Ref.: CVLNCCP02-G1-01

CVL Network – Network Code Condition G1 Network Change Proposal: Cardiff Bay Station platform changes and Overhead Line Electrification System (“OLE”) Commissioning Heath Junction to Caerphilly Bay Platform and Coryton

Appendix A – Proposed scheme for the energisation of the Overhead Line Electrification System (“OLE”) from Heath to Coryton and from Heath to Caerphilly

TRAN01-PSP-ZZ-CVL-DDR-Y-EP-000127-S1-P02 Caerphilly

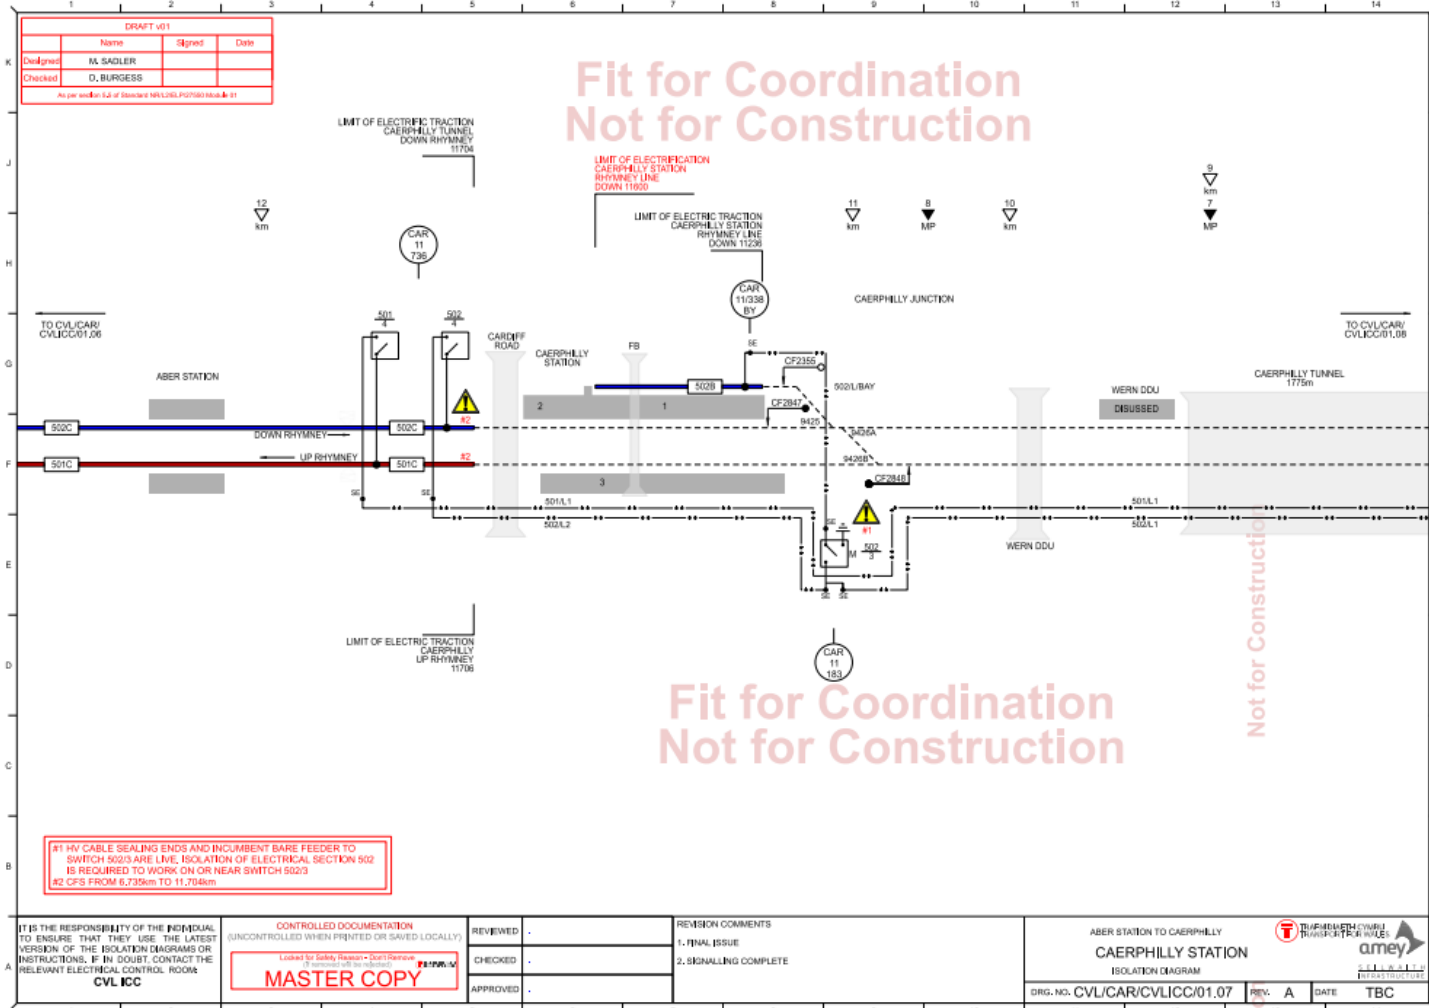
This energisation event will bring into use all 25kV OLE and HV distribution assets from the limit of electrification between Queen Street North and Heath Junction through to the end of the branch at Coryton and to the limit of electrification south of Lisvane and Thornhill Station.

The bay platform at Caerphilly Station will also have 25kV equipment brought into use via HV cabling from the limit of electrification south of Lisvane and Thornhill Station.

The part of the electrification system brought into use at this stage contains Permanently Earthed Sections (“PES”) at Birchgrove Station & Caerphilly Road Bridge. Trains will require a compatible on-board energy system to pass through these PES areas.

TRAN01-PSP-ZZ-CVL-DDR-Y-EP-000129-S1-P02 Queen Street North MPTSS to Heath Junction

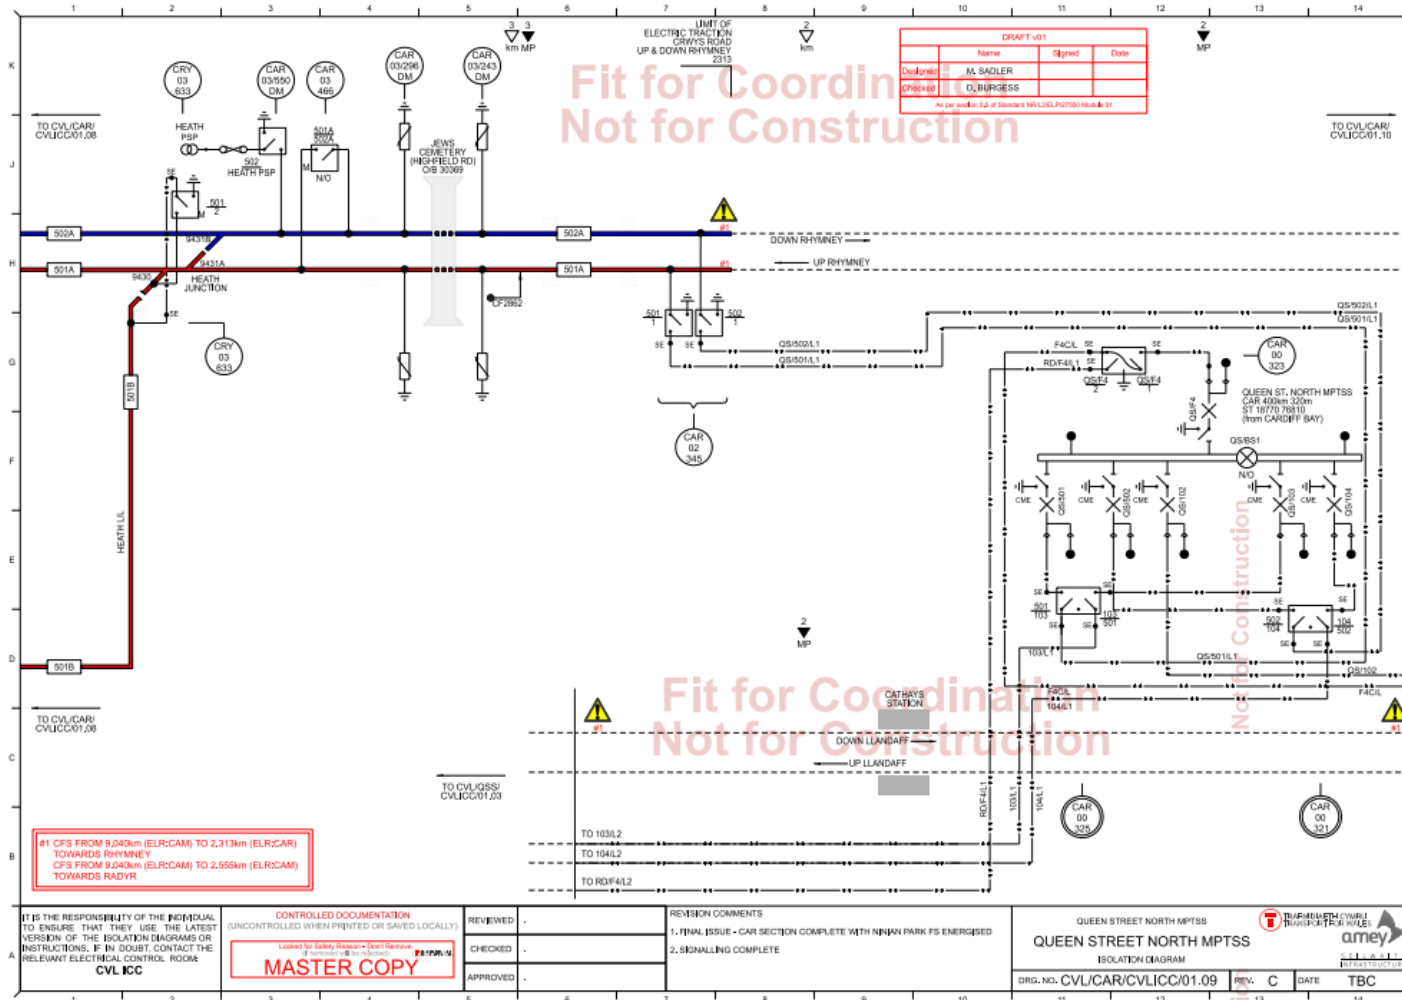
This will include the commissioning of a new substation at Queen Street North Junction.
